Recreation - Earlier version A – in the packet for March 24th - "MP2\_After\_10-Mar-2025.pdf"  
[https://www.richmondvt.gov/fileadmin/files/Andrews\\_Community\\_Forest/Meetings/2025/03/d2\\_MP2\\_After\\_10-Mar-2025.pdf](https://www.richmondvt.gov/fileadmin/files/Andrews_Community_Forest/Meetings/2025/03/d2_MP2_After_10-Mar-2025.pdf)  
 Section 2.9 and Sections 7.2 – 7.6

## 2.9. Recreation

*Note: Brad is proposing a reworked, shortened version as a consolidated alternative to the two Recreation sections 2.9 and 7 in the document “[Recreation and Appendix 2-26-25.docx](#)”. It’s aimed at resolving many of the issues flagged in Section 7.)*

**Figure 5:** Slopes of terrain in the ACF, with proposed trails overlaid. Richmond's Zoning Regulations identify special provisions for development on slopes greater than 20%, and greater than 35%. Map source: Vermont [Interactive Map Viewer](#).

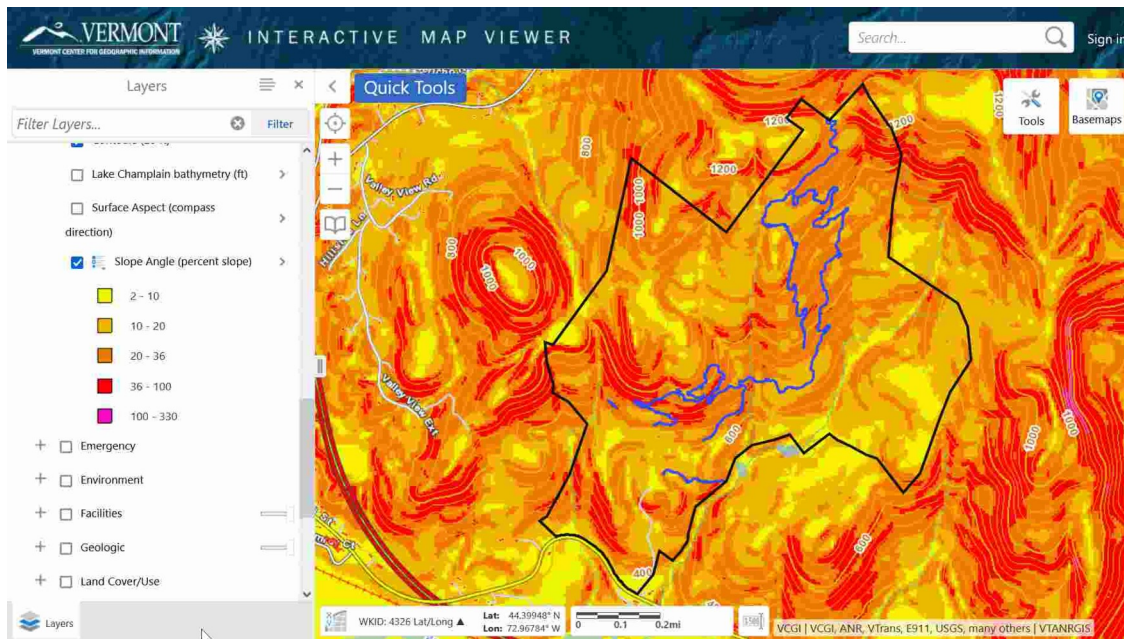
*[BE: A map showing only slopes from 20-35% and above 35% would be more helpful. It would probably also be better if placed in the Trail Stewardship Plan, along with other maps showing ACF's landscape-,*

*community- and species-level attributes.] [IS: Not easy to make changes to this map – but it uses slope thresholds that happen to be the ones in Richmond’s Zoning.]*

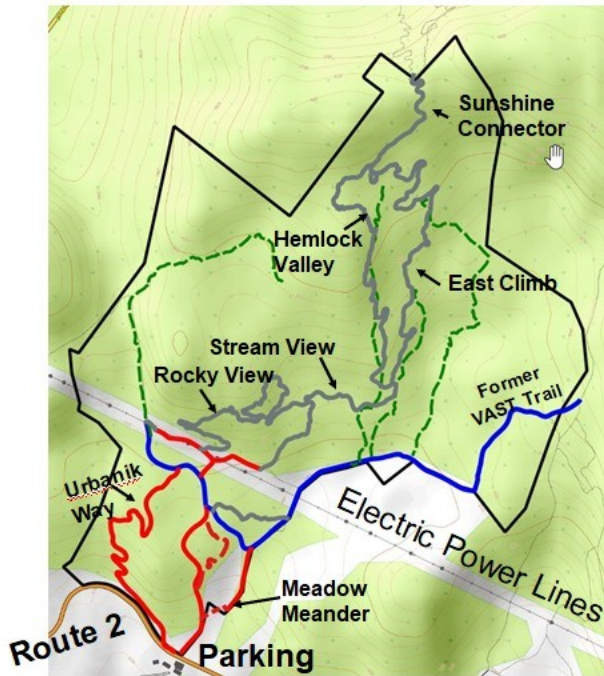
*[BE: As with streams, trails should perpendicularly cross the boundary to minimize traffic impacts along that boundary.]*
